**SITE DEVELOPMENT PLAN
PETITION REVIEW REPORT**

Petition Number: SUE 20-03

Project Name: Panera Site Plan Review

Requested Action: Special Use Exception for:
New Construction
Front Yard Parking
Drive-Through Facility

SITE PLAN

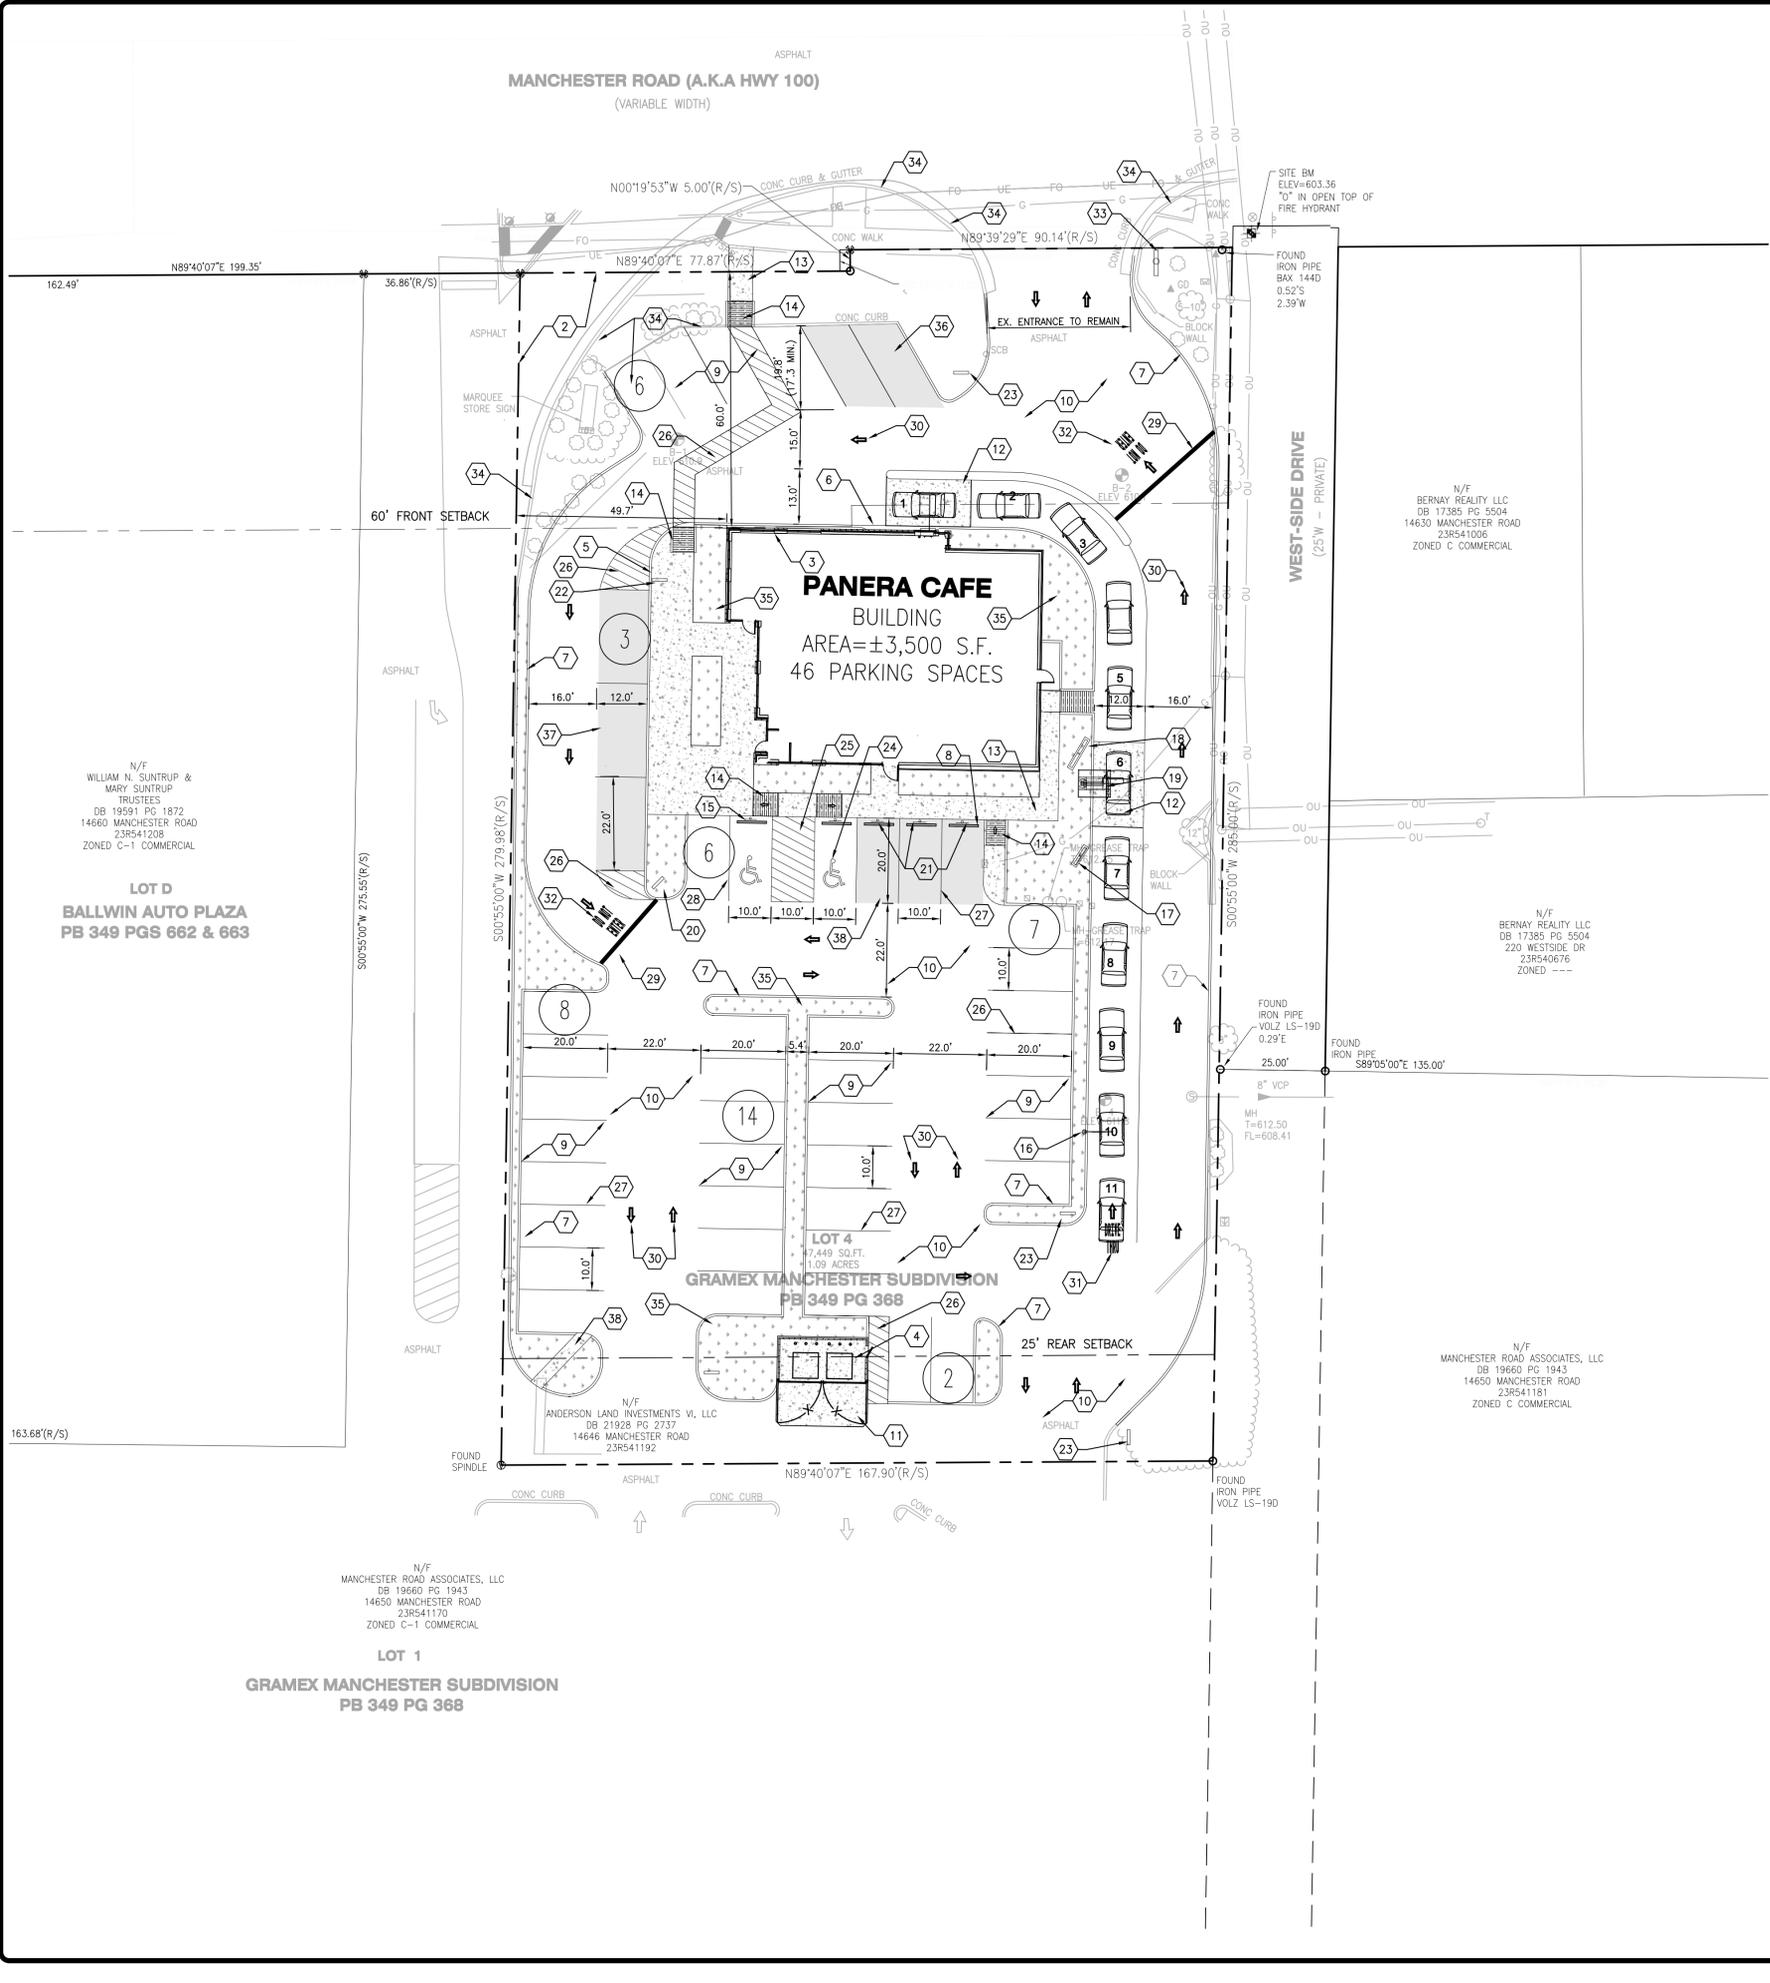
- Art. IX, Sec. 4 (4) refers to improvement of a C-1-zoned parcel with single-family dwellings, and is not pertinent to this evaluation.
- Art. IX, Sec. 5 (1) refers to off street parking and loading spaces, requiring that it comply with Article XV, Section 1 (16), which states that a restaurant, café, or similar recreation or amusement establishment be allowed one parking space for each 200 square feet of floor area or one parking space per four seats in the restaurant, whichever is greater. The square footage of the proposed building is set to be approximately 3,500. $(1/200) * 3,500 \text{ sq.ft.} = 17.5$, or 18 spaces rounded up vs. $95 \text{ proposed interior seats} + 34 \text{ exterior seats} / 4 = 32.25$, or 33 parking spaces rounded up.

Together with the standard parking spot regulation, 2 handicap accessible parking spot is required for 26-50 standard parking spots, and 1 van accessible space is required for 6 handicap accessible spaces. As such, a bare minimum of 35 (33 standard, 1 handicapped accessible, 1 van accessible) spaces are required. The parcel has 46 spaces that will be available, well beyond the requirement.

- Art. XIV, Sec. 2 (5) refers to parking. Parking was discussed earlier in this report under Art. IX, Sec. 5 (1). The proposed use appears to have an amount of parking well beyond what the minimum required amount is based on APA Parking standards from 2002.

- Art. XIV, Sec. 2 (10) refers to adequate area for the use. The amended site development plan provides evidence that it has more than the minimum parking sufficient to meet the needs propagated by the use proposed for the site. It should also be noted that the previously approved tenant at this address was also a restaurant, so there is no basis for concern about there being insufficient room for the intended use.

- Art. XIV, Sec. 2 (12) refers to rubbish and trash disposal and screening. The proposed use could certainly generate substantial trash. The site development plan shows a dumpster location to the rear of the parcel, and will be sufficient for this evaluation.
